## REPORT

**From:** Emilie K Adin, MCIP      **File:** SDP00198  
 Director of Development Services

**Subject: 514 Carnarvon Street: Holy Trinity Cathedral Restoration and Mixed Use Tower – Project Update**

# TOWER DESIGN UPDATES

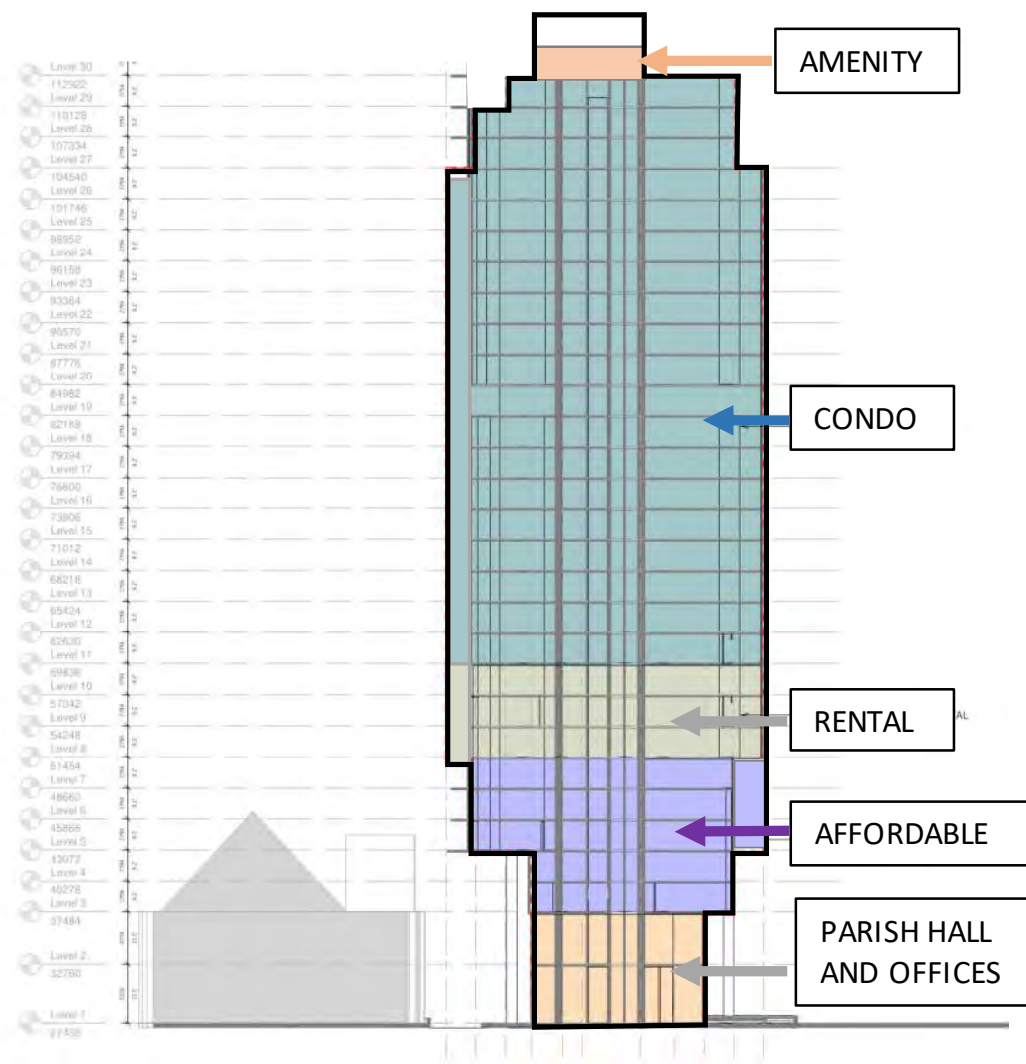
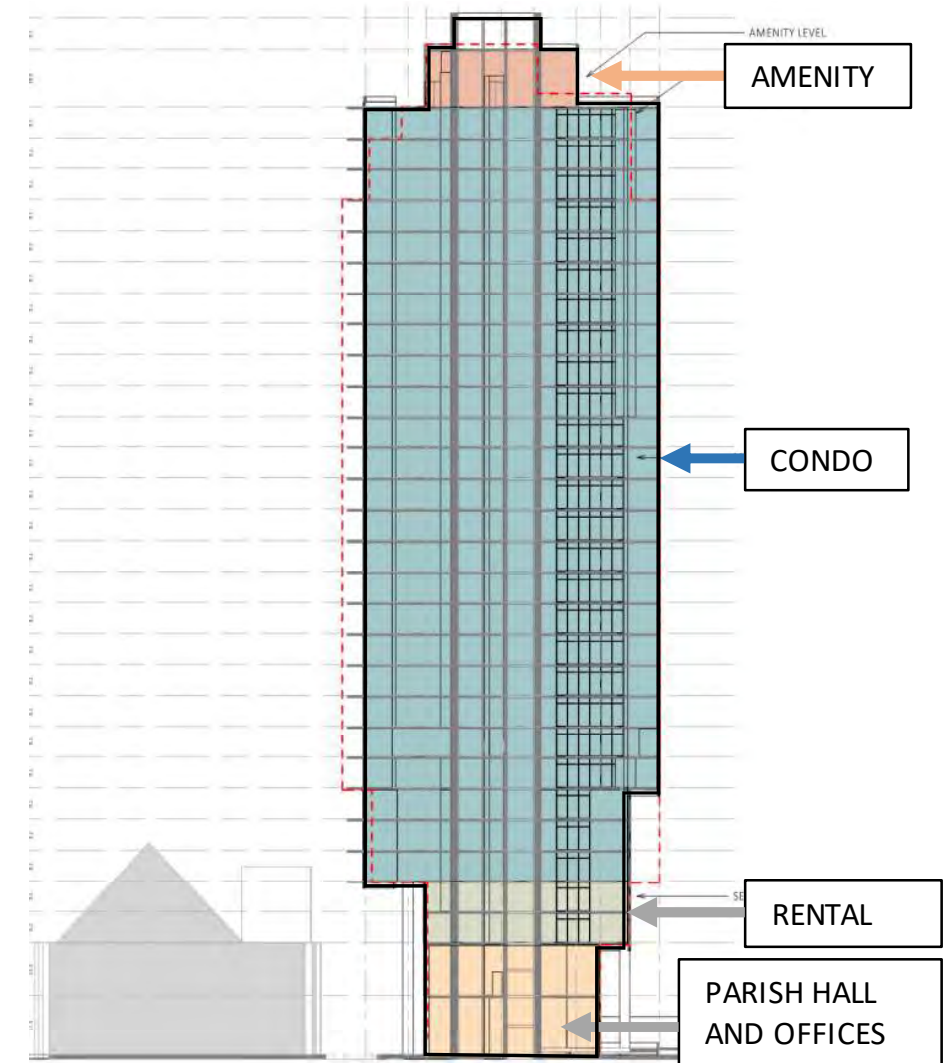
There remain some unresolved design issues in the current proposal. As was identified in previous proposals, the relationship between the tower massing and the heritage cathedral does not yet meet the Canadian Standards and Guidelines for Heritage which specify that a new intervention on a heritage site should be compatible with, subordinate to, distinguishable from, and respectful of the heritage asset.

While staff recognize that the tower will never be subordinate in size, through design (e.g. through the use of lighter materials, stepping massing away from the cathedral), it can meet the intent of the Standards and Guidelines. This is currently most successful at the base of the tower, but staff considers that additional work is needed in the body of the tower (e.g. further building articulation and detailing, mindful selection of building materials). Generally, compatibility of design between the two buildings requires further refining. This is consistent with comments raised by the New Westminster Design Panel.

*Does the LUPC support staff continuing to work with the applicant to revise the design of the tower to improve the relationship between the tower and the cathedral to be more consistent with the Standards and Guidelines for the Conservation of Historic Places in Canada?*
